Before a Board of Inquiry
MacKays to Peka Peka Expressway Proposal

in the matter of: Notice of requirement for designation and resource consent applications by the NZ Transport Agency for the MacKays to Peka Peka Expressway Proposal

Statement of rebuttal evidence of **Boyden Evans** (Landscape) for the NZ Transport Agency

Dated: 26 October 2012

**ANNEXURE 3 – WOO ALTERNATIVE ALIGNMENT TRANSPOSED
ON TO AERIAL PHOTOGRAPH**

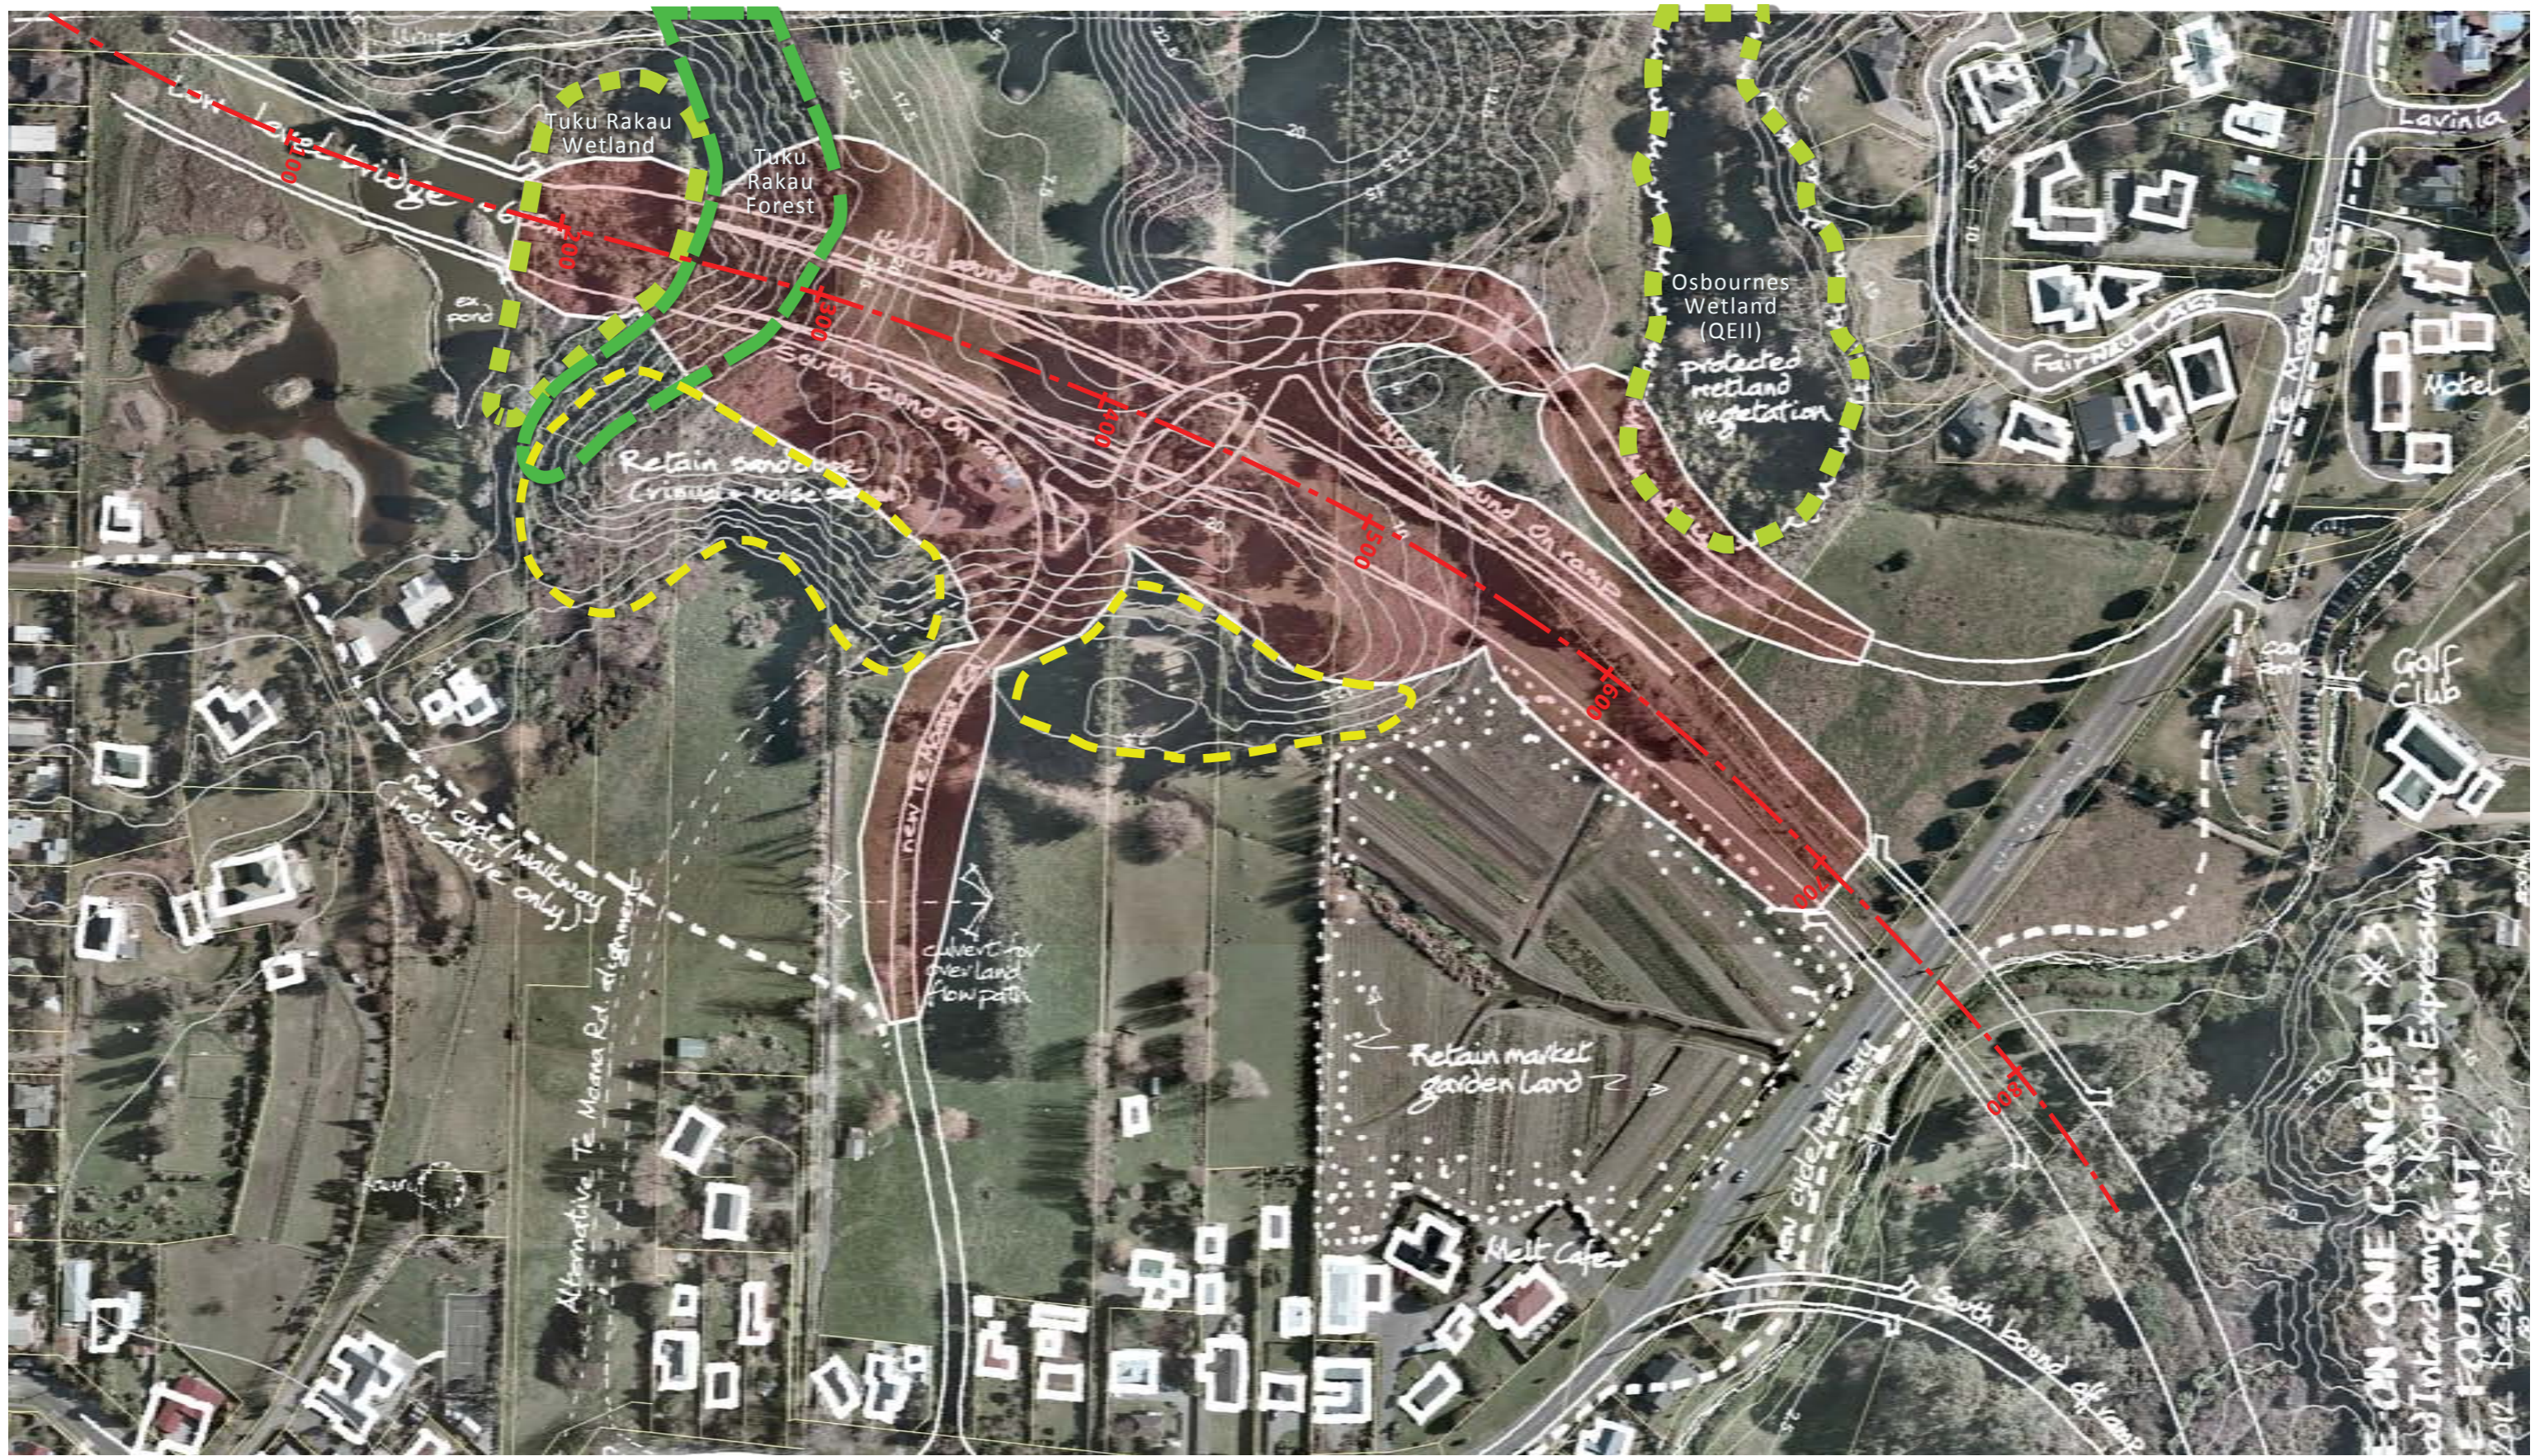
88 To be able to fully **consider Ms Smith’s sketch option I have** had it transposed onto an aerial photograph and have also prepared a long section from the contour information used for the Project to help compare the two proposals. In addition, I have also transposed contours and the Project alignment onto a copy of **Ms Smith’s** plan. I have also discussed this material with **Messrs Nancekivell and Levy**. Those plans are now attached to my evidence (**Annexures 2 and 3**).

89 In Ms Smith’s proposal, the Expressway would be on a low level bridge after crossing the Waikanae River, cutting through the dunes in the vicinity of El Rancho. The route runs along the toe of the **urupā** and then cuts through the large crescent shaped dune before crossing west of the flat market garden area and the Waimeha Stream on a second low bridge. Te Moana Road would be realigned south, so that it crosses over the Expressway with an elevated ‘doughnut’ type roundabout arrangement.
